# City of Hapeville

# **Design Review Committee**

August 21, 2019

# DEPARTMENT OF PLANNING AND ZONING PLANNER'S REPORT

# **FINDINGS**

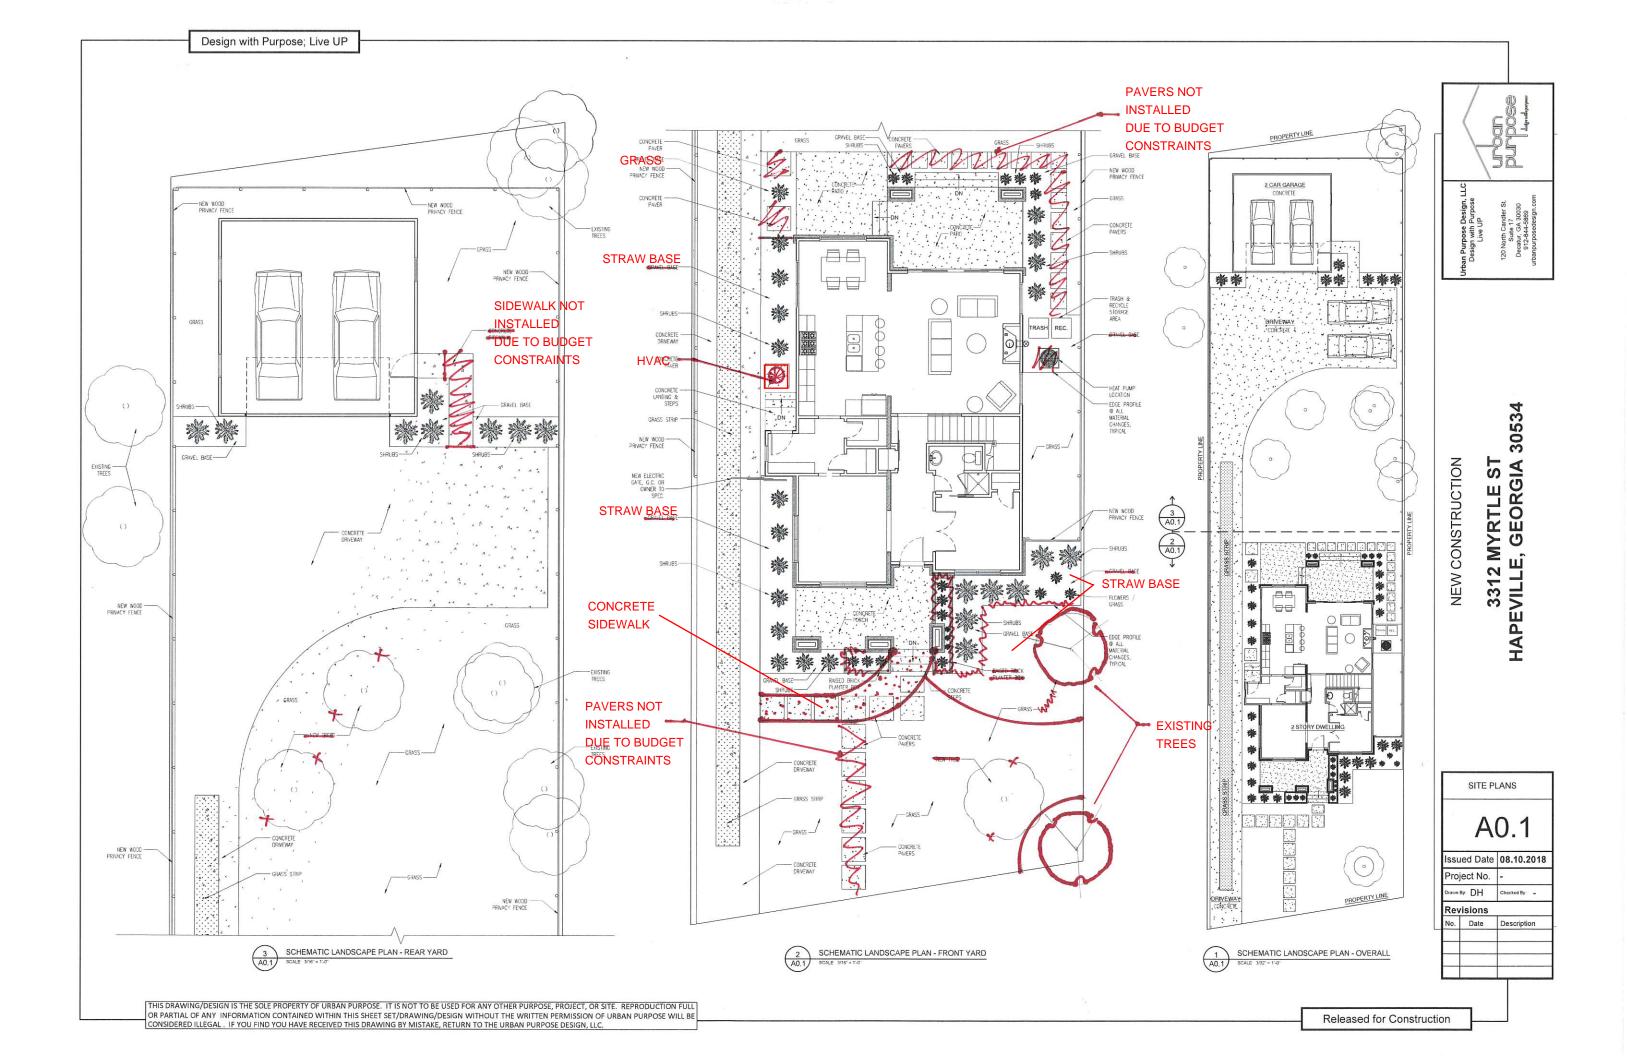
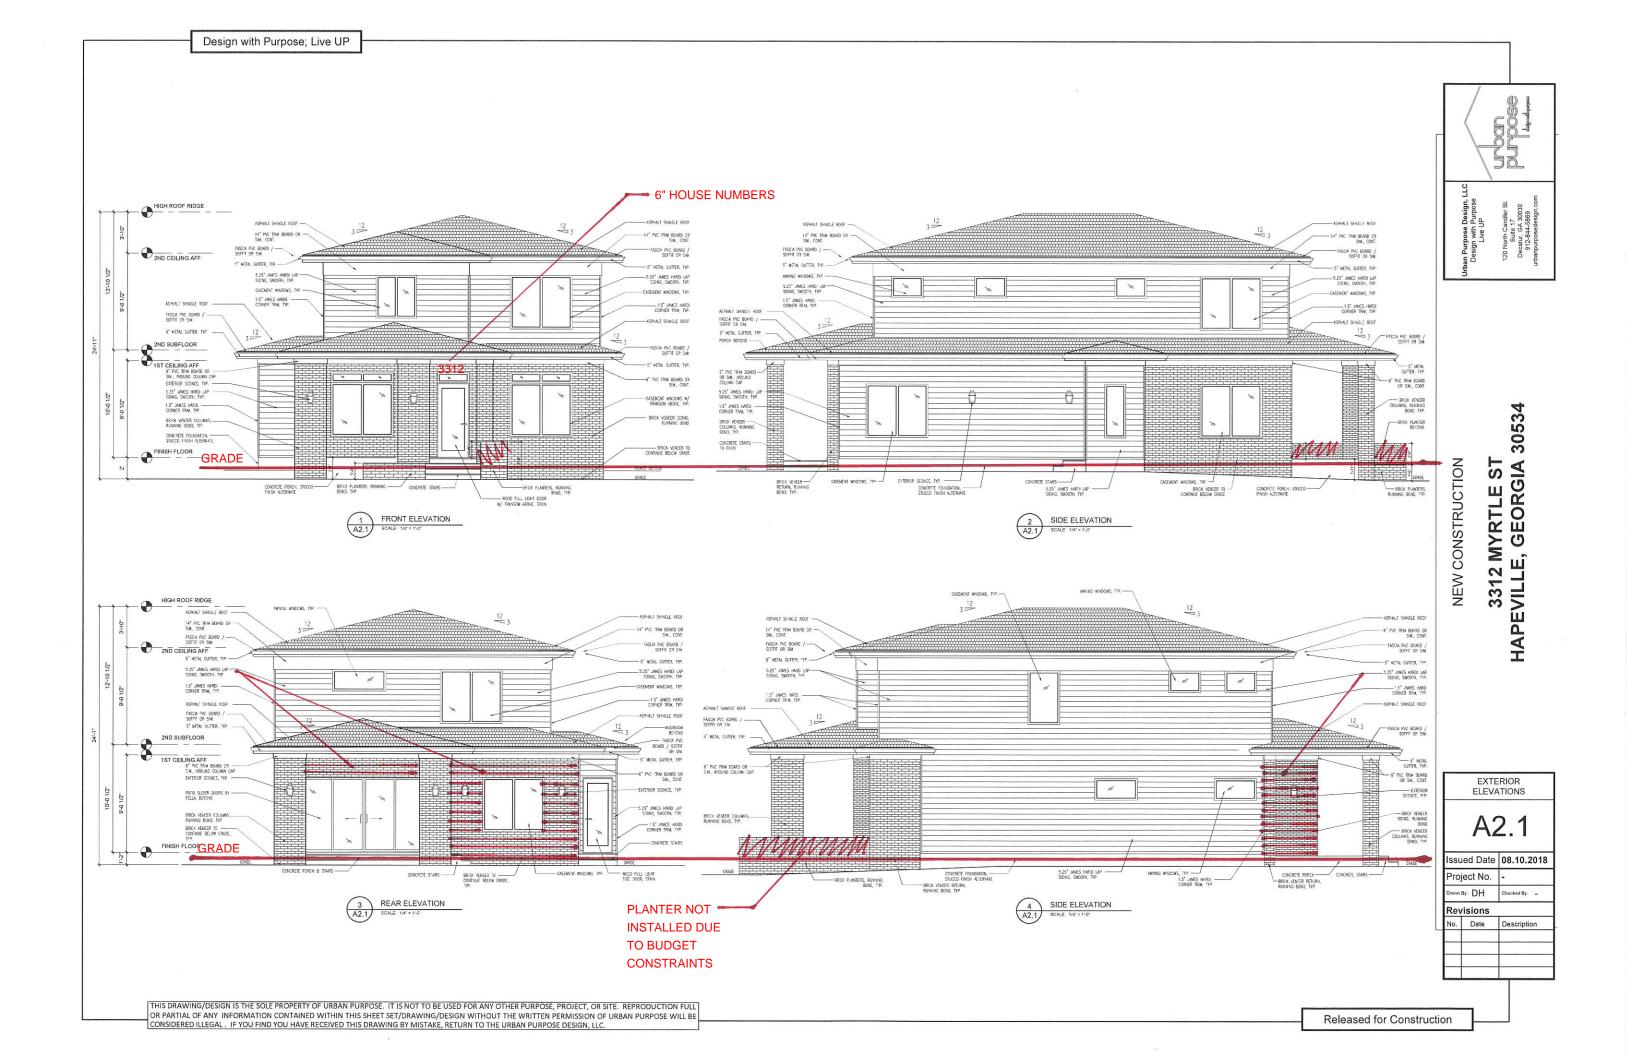
The following are observed deviations in the final construction from the design plans approved by the Design Review Committee, and are not compliant with the Architectural Design Standards:

1. The house was built at-grade, rather than raised 2' as in the plans.

- 2. There are no building numbers adjacent to the front entrance, as noted in the original planner's report.
- 3. Multiple windows are not recessed 2" from their adjacent facades as required by Sec. 81-1-7(g)5 and discussed at the November 15, 2017 DRC meeting.

4. The trim around the windows does not appear to be 4"-6" and is not wooden (or wooden in appearance). Mullions are wider than existing trim but would not be 2" wider than the required trim. Trim and mullion requirements were conveyed by the City Planner on September 7, 2018.

5. There is no walkway connecting the front entrance to the sidewalk. The plans show a walkway made of pavers connecting the entrance to the street.

- 6. Mechanical has been relocated (it is not visible from the right-of-way but is not screened).
- 7. Landscaping does not match the landscape plan.
- 8. The rear façade is now Hardie Board rather than brick.

The final design of the house as constructed deviates from the approved designs and is not compliant with the Architectural Design Standards. The applicant must submit revised plans to the City and present the plans for approval to the Design Review Committee.

# **RECOMMENDATION**

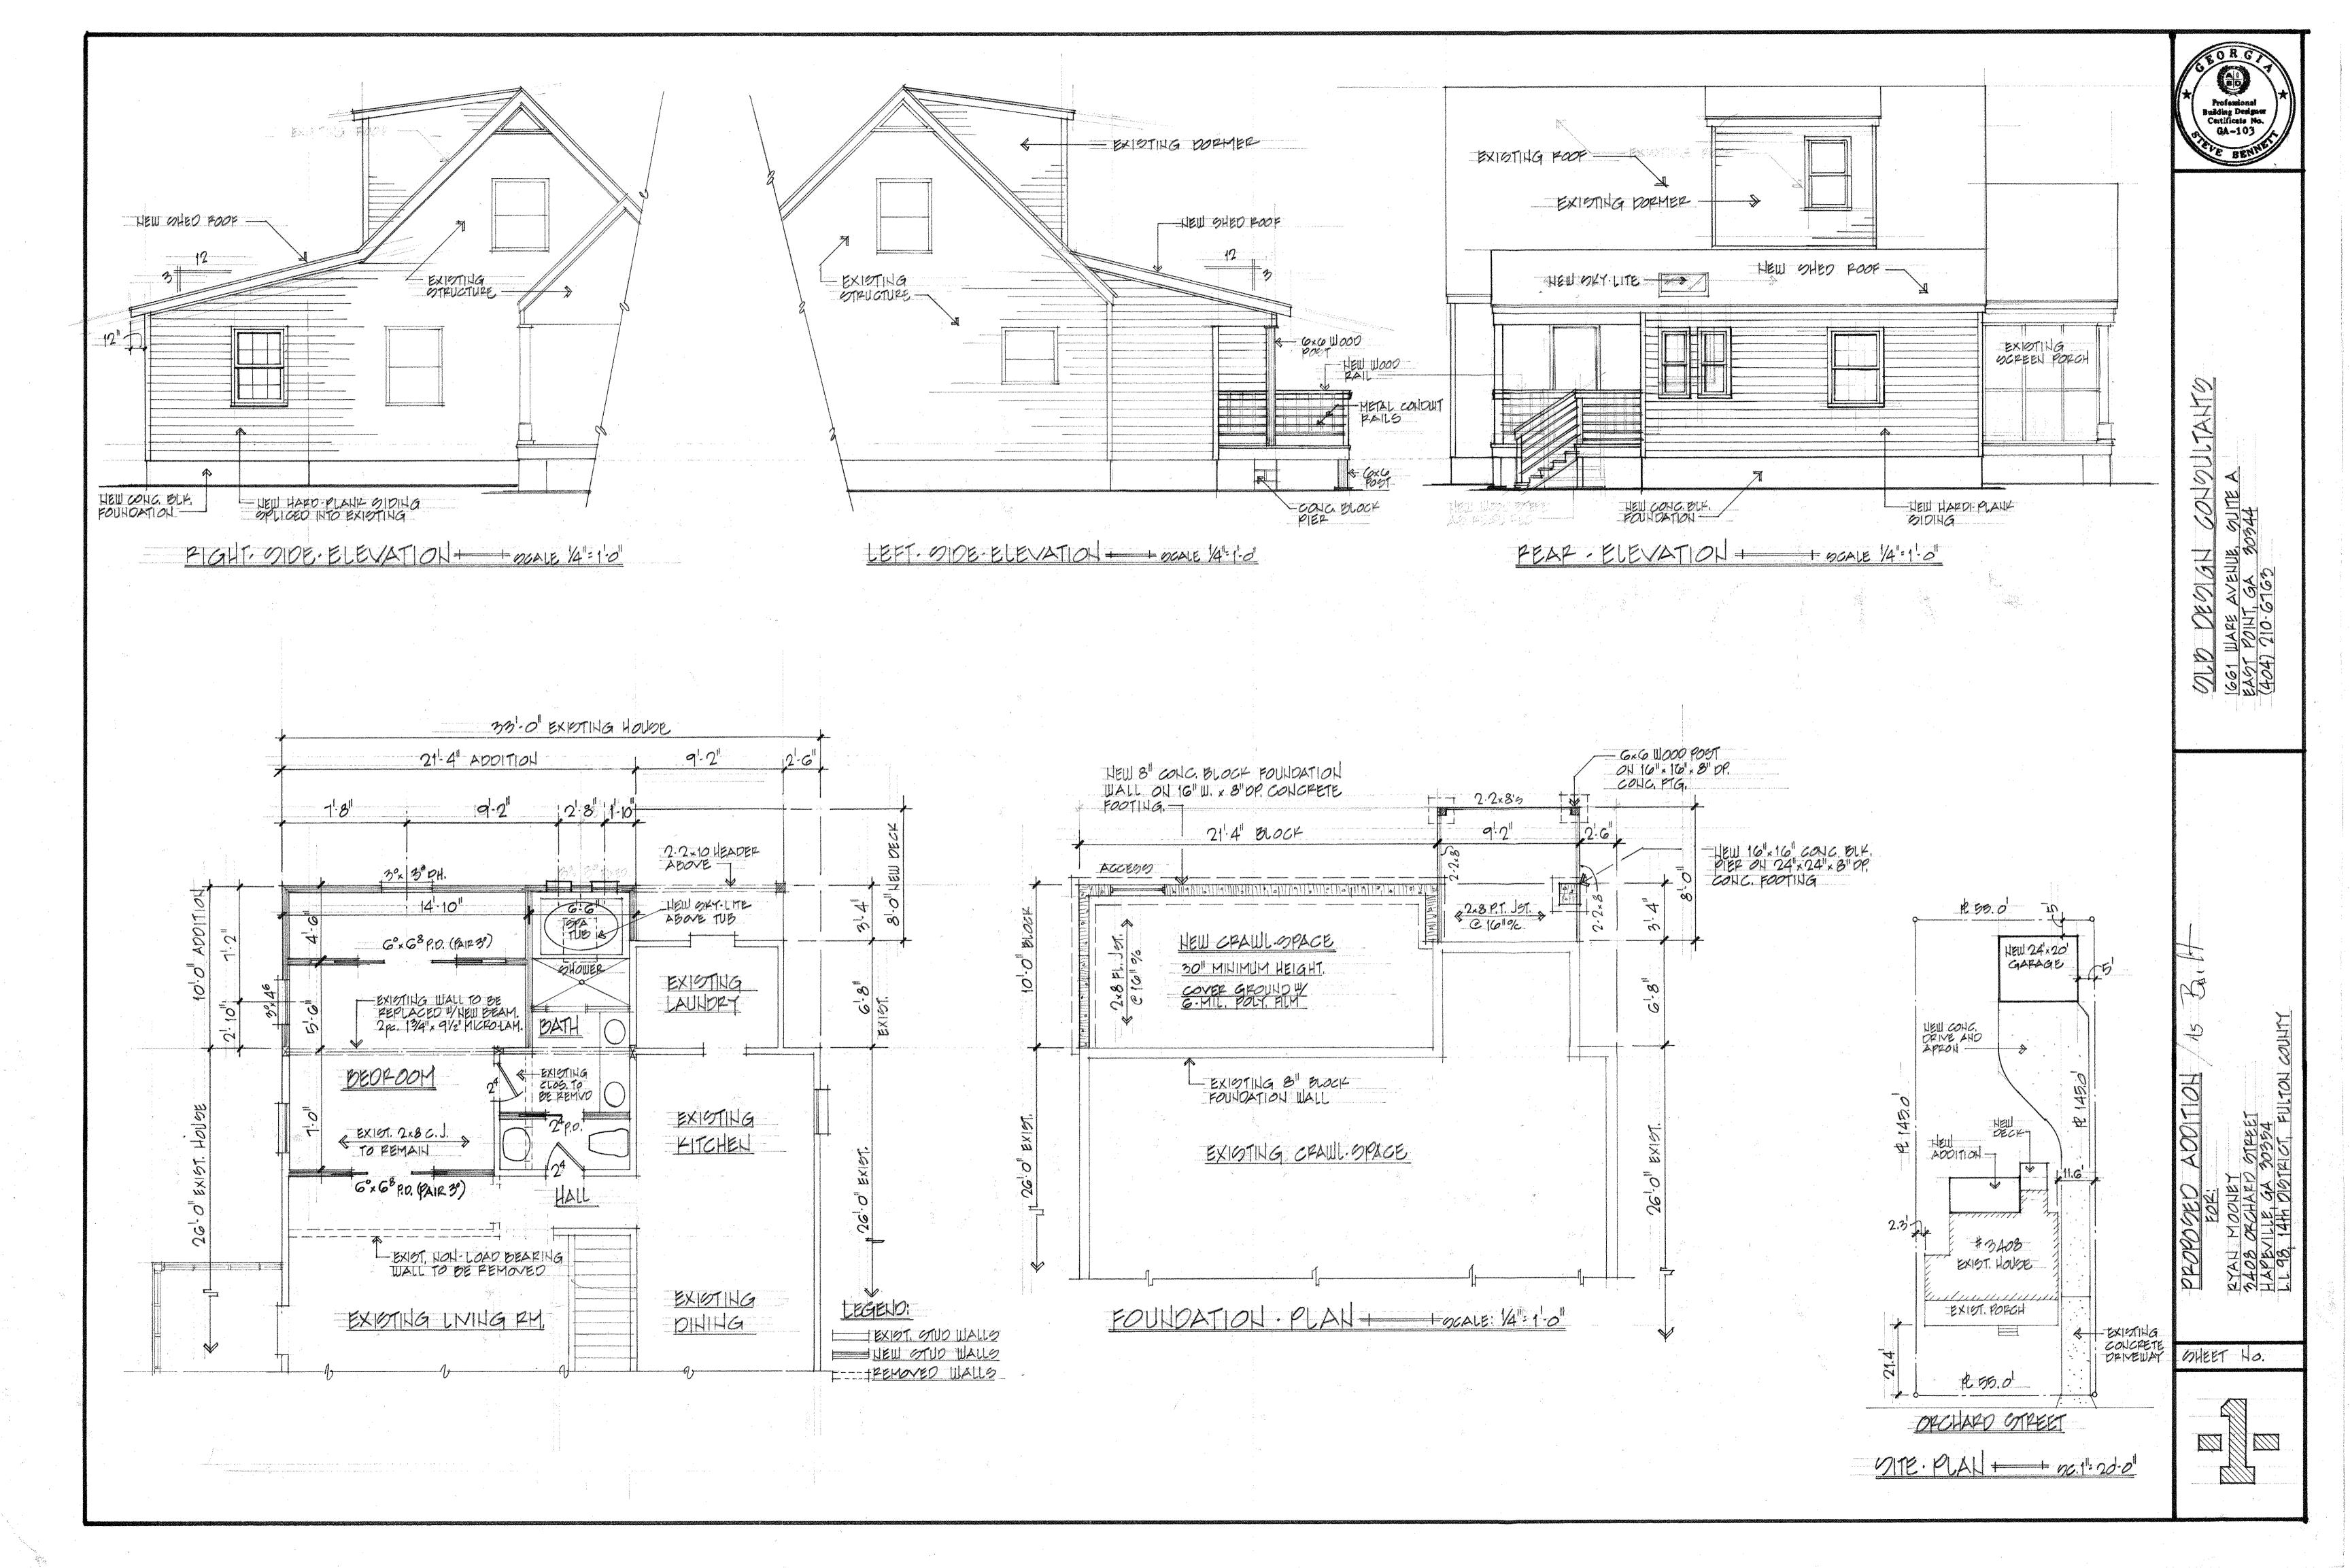
The following are observed deviations in the final construction from the design plans approved by the Design Review Committee:

1. A dormer has been added to the upper floor above the new addition.

2. Window configuration has been slightly modified on the rear façade.

3. The deck has a different configuration from the approved plans, and wooden vertical members have been replaced with metal horizontal poles.

The final design of the house as constructed deviates from the approved designs. The applicant will need to submit revised plans to the City and present the plans for approval to the Design Review Committee.
